# System Impact Assessment Report

### Addendum

**CAA ID:** 2006-224

**Project:** GTA West Transmission Reinforcement  
Huronario SS – Stage 1

Figure 3: Revised Sithe-Goreway Generation Runback Scheme

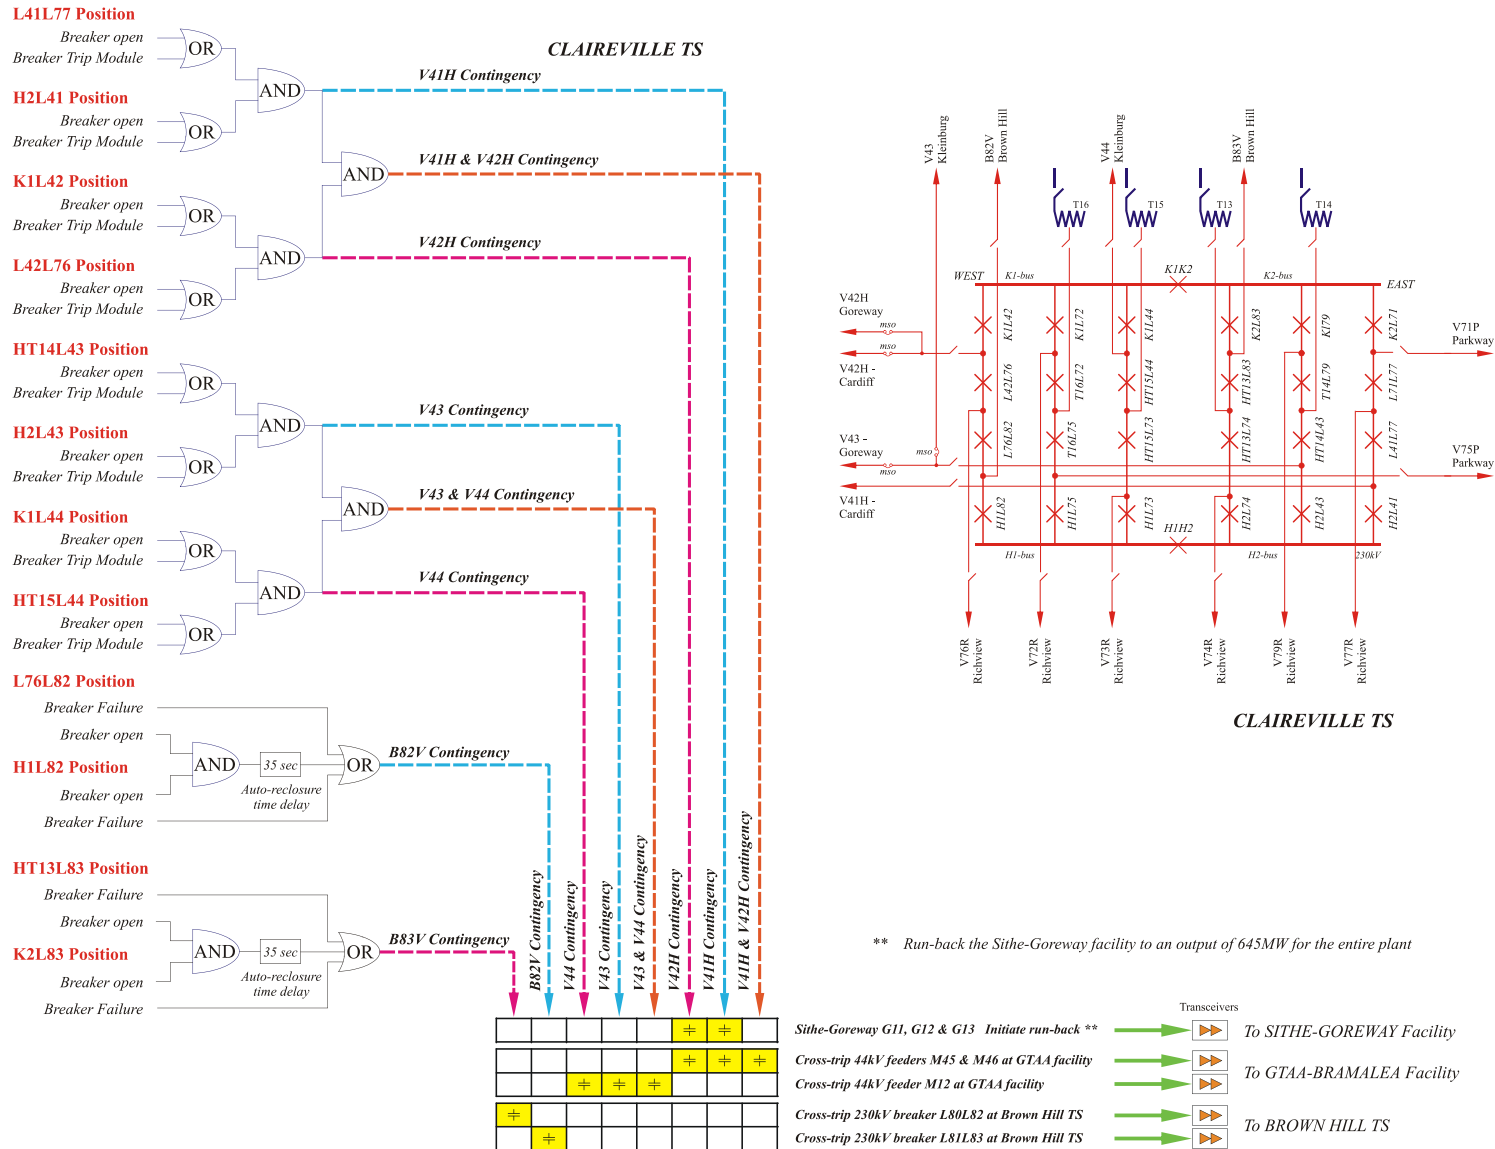
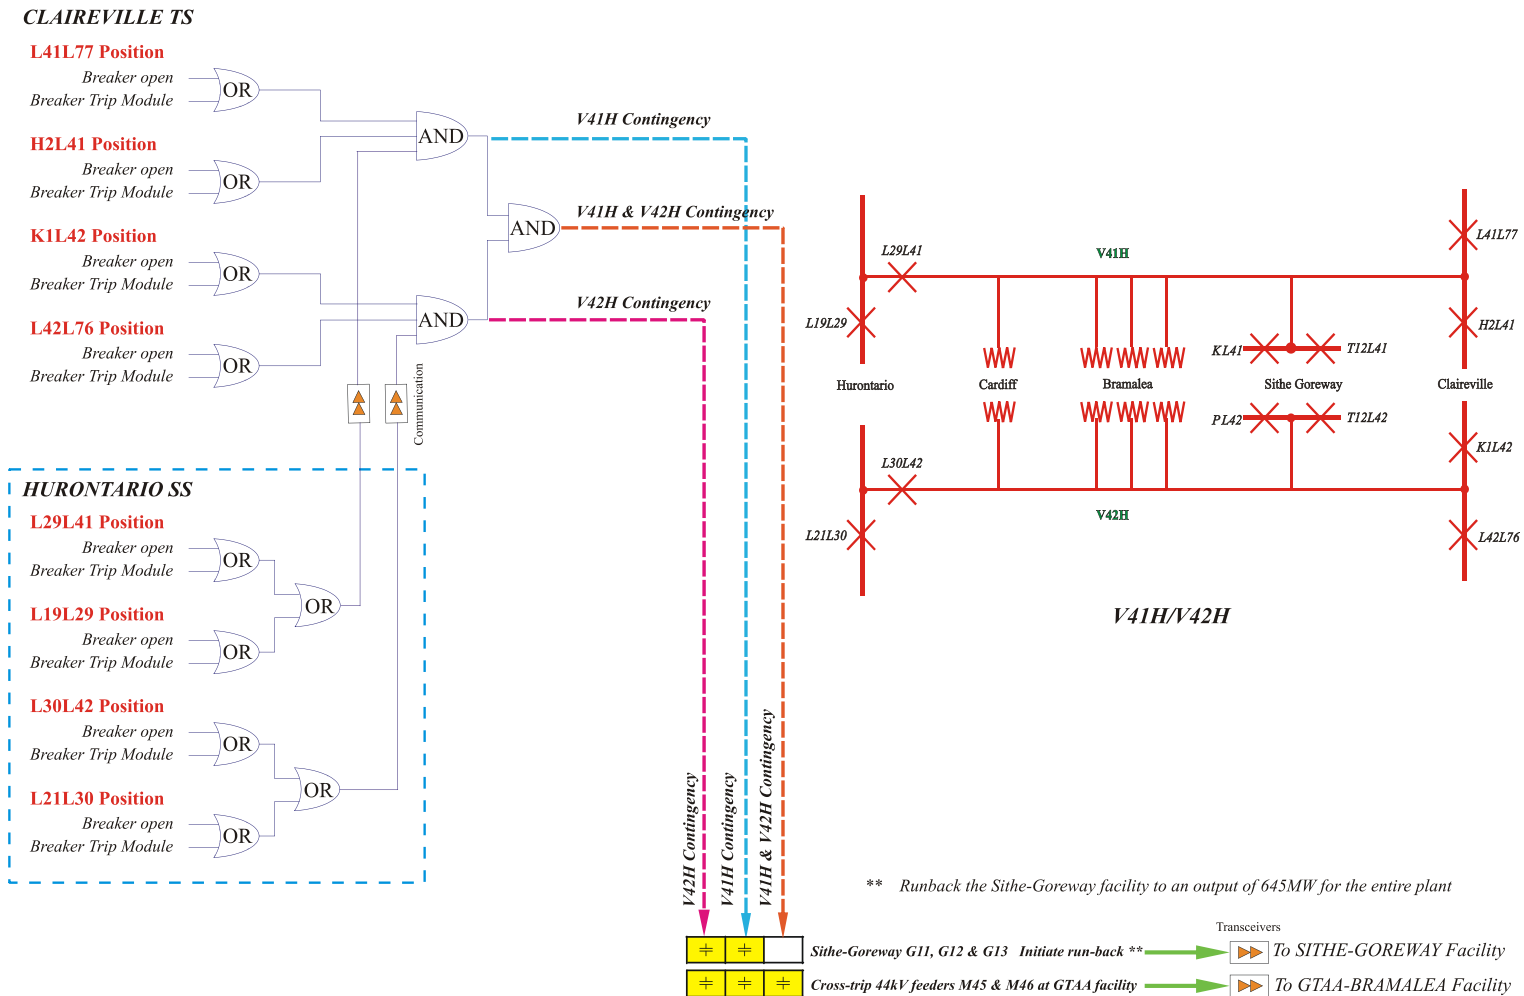
However, the overloading situations of circuits V41H/V42H may only occur due to the loss of the companion circuit, i.e. breakers open at Claireville TS and Hurontario SS. Since under the new system configuration the 230 kV lines V41H and V42H are no longer radial from Claireville TS, the contingency of LEO condition of V41H/ V42H does not result in any overloading. Thus, no generation runback at Sithe-Goreway CGS is required for the contingency of LEO condition of circuits V41H/V42H.

As the existing control logic, as shown in Figure 2, responds to both loss of circuit and LEO condition of V41H/ V42H, the contingency of LEO condition needs to be removed from the Scheme. To achieve this, the CB status of V41H/V42H at Hurontario needs to be utilized to enhance the control logic. The revised control logic of the Scheme is shown in Figure 3.

The revised Scheme requires additional communication channels between Hurontario SS and Claireville TS, which are costly, as confirmed by the applicant. Without the enhancement, the existing Sithe-Goreway Generation Runback Scheme may expose to over-arming for LEO condition of V41H/ V42H, but there is an insignificant impact on the system reliability of the IESO-controlled grid.

Similar situations would have to arise for the V42H LEO condition. Considering these situations for the LEO condition to occur, the probability of a LEO event of V41H/V42H is quite small. Thus, the IESO accepts the existing control logic of the Scheme and does not require any change to be implemented at this time. However, the IESO reserves the right to ask Hydro One in the future to implement the revised Scheme as shown in Figure 3.
